Service Bulletin

B26-02

Subject: SL12892 Thrust Button Material Deformation at Rocker Shaft Location.

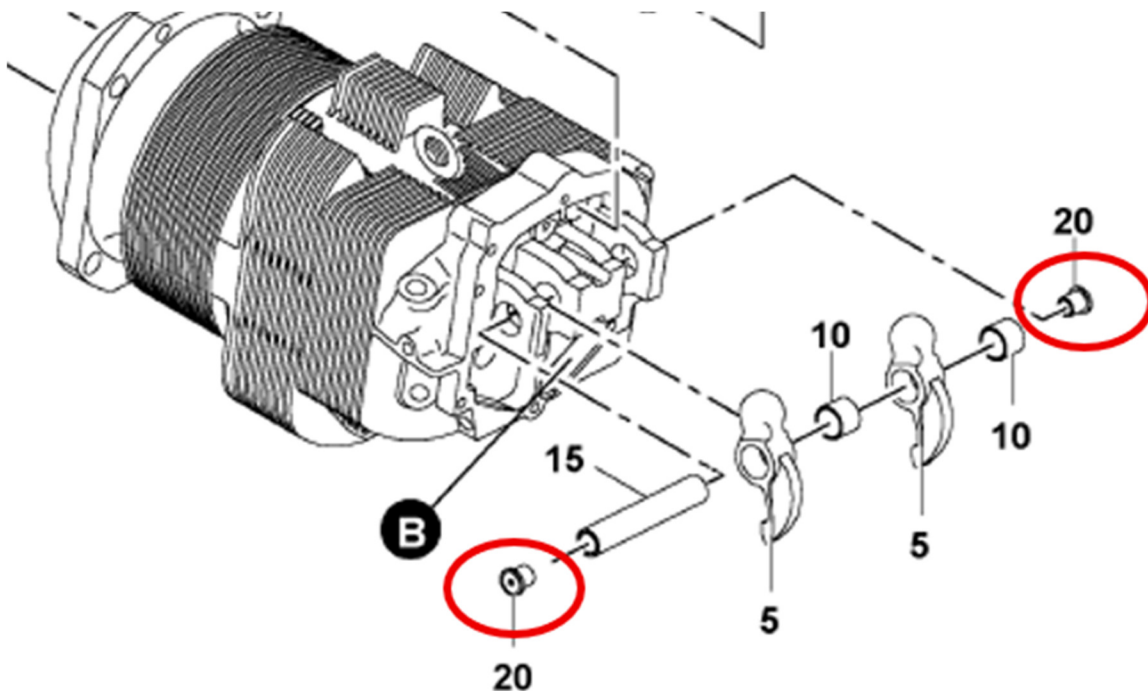
- A. Remove rocker covers, and gasket from the cylinder assembly, (discard rocker cover gasket).
- B. Inspect rocker box areas and rocker shafts for the following conditions:
 - Deformed/ Melted thrust buttons
 - Missing or partially missing thrust buttons
 - Inspect rocker cover area for material or residue
- C. Remove rocker shaft thrust buttons (20), part number SL12892, from each rocker shaft.
- D. Evaluate the condition of each removed thrust button and discard regardless of condition.

- A. Discard all removed thrust buttons regardless of condition.
- B. Install new thrust buttons using Service Kit **B26-02**.
- C. Install new rocker cover gaskets supplied in Service Kit **B26-02**.
- D. Reinstall rocker covers.
- E. Torque fasteners in accordance with the applicable engine maintenance manual.
- F. Make an engine logbook entry of compliance with Superior Air Parts Service Bulletin B26-02.
